Certificate of Appropriateness

1019 E. Brady Street

PORCH REPLACEMENT
1017 E Brady St #1019,
Milwaukee, WI 53202

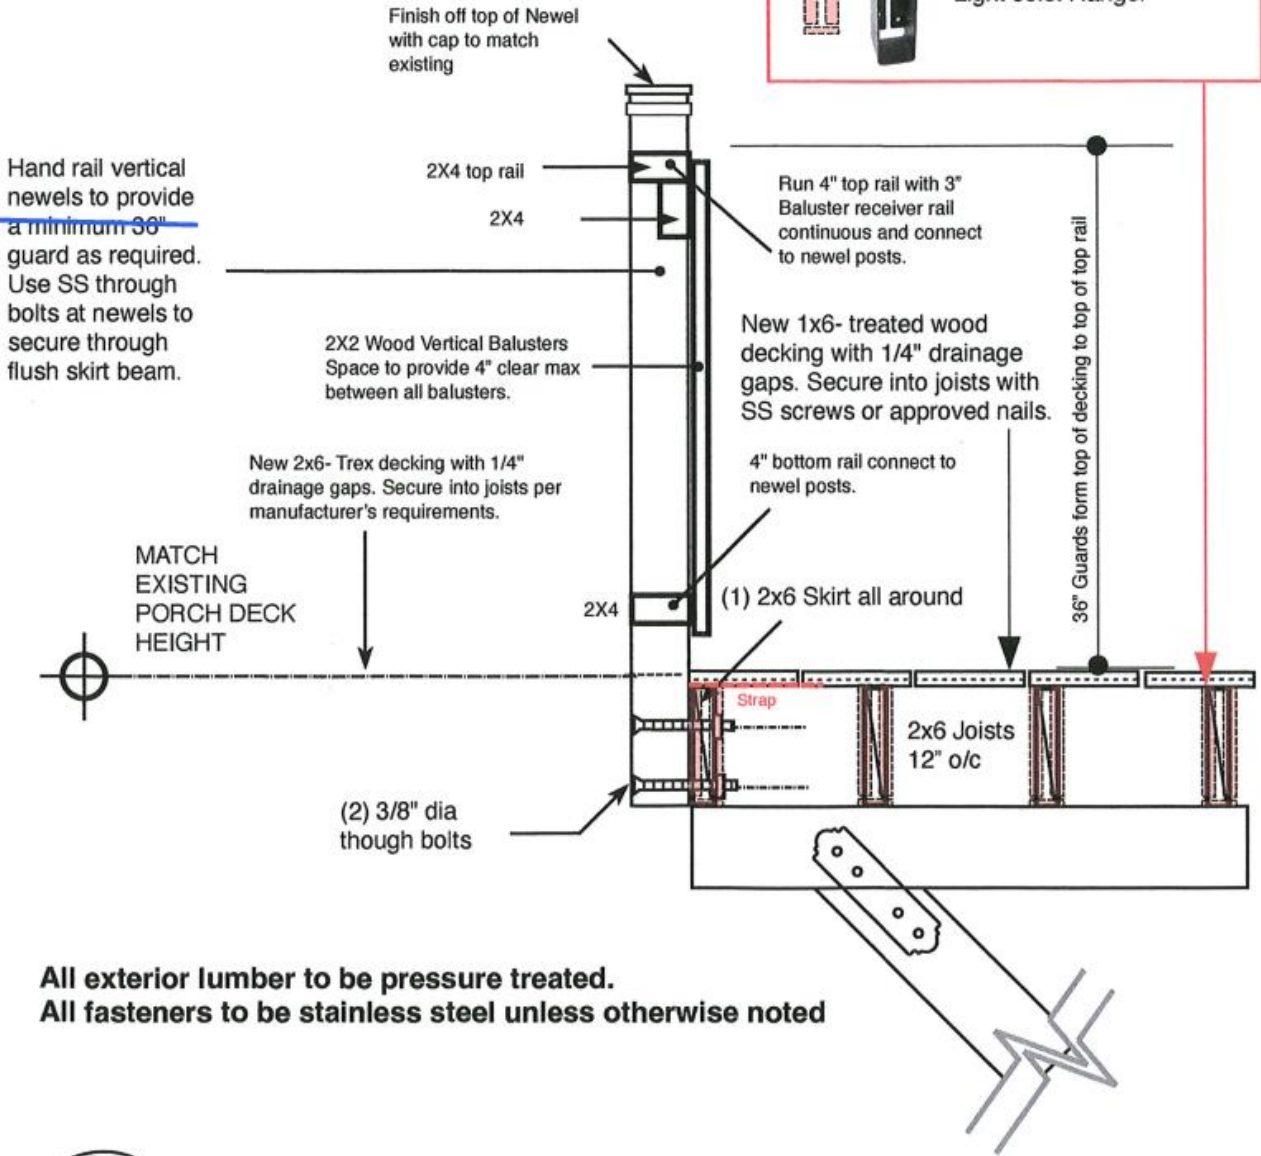
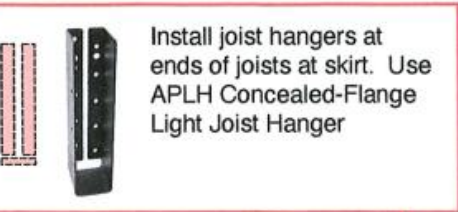
This form of pre-built railing is not allowed.

Replace existing jump porch. Use 42" railing. Railing shall match the hand drawings, not the computer generated drawings. Use railing design and construction technique shown on pages 4 through 5.

1
A-101
TYPICAL RAILING AND DECK STRUCTURE
SCALE: 1"=1'-0"

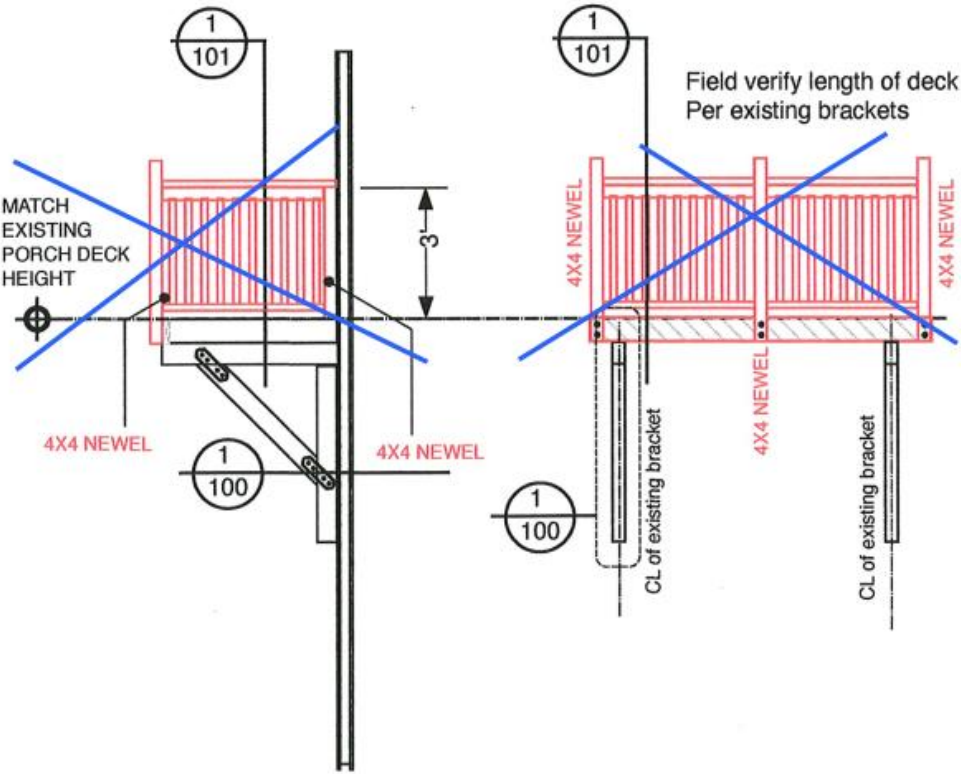
DO NOT USE RAILING SHOWN ON THIS PAGE
